Selwyn District Council Comment on the Faringdon South West and South East Development

3. Please provide your comments on this application

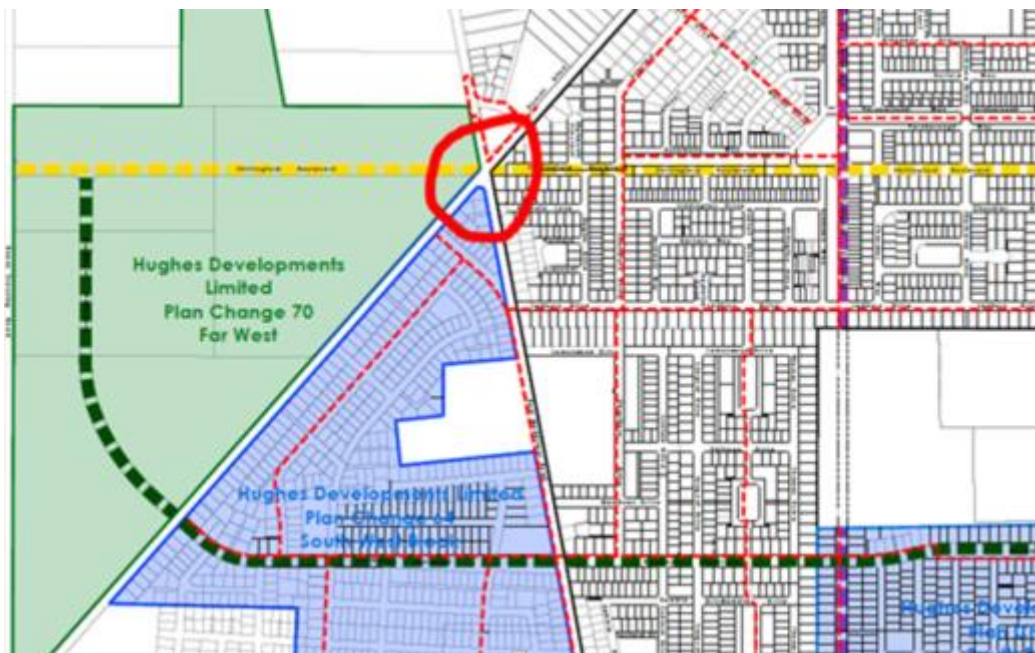
60. The intersection of Springston Rolleston Rd and Selwyn Rd is on two arterial routes. It is planned to be upgraded to a roundabout to address the rapidly increasing safety risks it poses from additional traffic in the area, in particular the Selwyn Rd arterial route. The Applicant and Council agreed to develop a concept plan to identify what would be envisaged, and in particular identify what land was needed from the intersection quadrants to either protect or plan for that outcome. At that time a concept and layout for a double lane roundabout was produced. Council has since progressed this concept into more detailed options by its expert traffic consultant GHD Ltd. The preferred option below has been identified using a single lane roundabout (subject to final modelling results) which reduces the land needed from the surrounding properties while still achieving the traffic and safety outcomes required.

61. In previous discussions with the NZ Transport Agency it was identified that this upgrade project should occur in the 2024-2027 period, based on normally expected future traffic use and increasing safety issues. The potential 'fast tracking' of this development will accelerate traffic use and safety concerns. Selwyn Rd is a fast growing arterial route, mostly due to the traffic generated by previous Faringdon stages, and the connection Selwyn Rd provides for commuters from southern Rolleston areas to Christchurch. Springston Rolleston Rd is also the main arterial connection to Lincoln.

62. It is Councils view that the Applicant share in these costs to upgrade the intersection as a condition of any 'fast track' approval, as this upgrade also needs to occur sooner to address safety issues at this key intersection as traffic will increase earlier than was expected. It is estimated the upgrade could cost up to \$4 million based on the costs of similar roundabouts currently being constructed on the main arterial roads at Prebbleton by Council. The application, if approved, is likely to accelerate issues at this intersection well ahead of planned upgrades. On that basis it is recommended that the Applicant contribute significantly (up to 50%) to those costs and that the upgrades are constructed no later than by the completion of Stage 2 of the proposed site development. Council is happy to, and expects to,

enter in discussions with the applicant around the development of a 'developer agreement' for the construction and cost of this infrastructure. These discussion would normally happen through processing of a subdivision consent by Council. Given the nature of the 'fast track' process these discussion have not been had. It is recommended that developer agreement is a condition of consent.

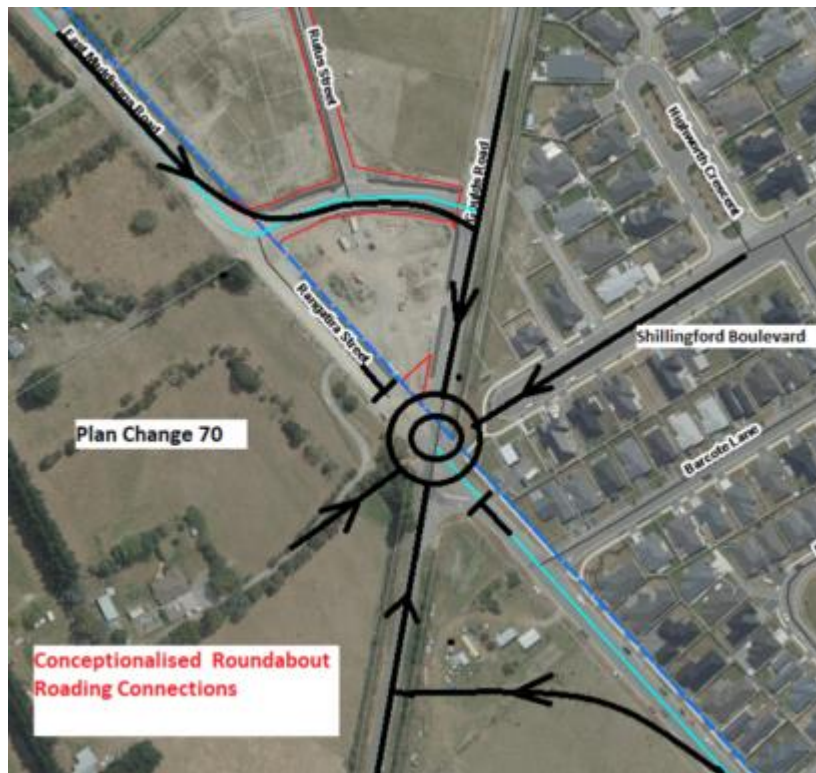
67. However there is no indication that the top area of Stage 9, and the lot layout proposed plus access requirements, can accommodate the proposed roundabout upgrade. Equally the same can be said how the top end of East Maddisons Rd around Barcote Dr will be adapted to the roundabout outcome required.

68. Considering the traffic generation expected from this site, and the key position of this juncture for traffic in the area, this intersection is in a similar position to the Springston Rolleston/Selwyn Rd intersection discussed above as needing to be also progressed as part of any 'fast track' approvals for this development. It is also well past time that Shillingford Dr is connected to the existing local network, rather than just remaining an unfinished dead end from the original areas of Faringdon. Prior to these fast tracking intentions, Council in its current 2021-31 Long Term Plan had identified to provide the intersection upgrade in 2029/30 at a currently estimated cost of \$2.5 million.

69. As with the Springston Rolleston/Selwyn Rd intersection the application, if approved, is likely to accelerate issues at this intersection as well ahead of planned upgrades. On that basis it is recommended that the Applicant also contribute significantly (up to 50%) to those costs and that it is constructed no later than the completion of Stage 6 of the proposed development, which connects Northmoor Boulevard onto Goulds Rd. Again, Council is happy to, and expects to, enter in discussions with the applicant around the development of a 'developer agreement' for the construction and cost of this infrastructure. As discussed above these discussion would normally happen through processing of a subdivision consent by Council. Given the nature of the 'fast track' process these discussion have not been had. It is recommended that developer agreement is a condition of consent.
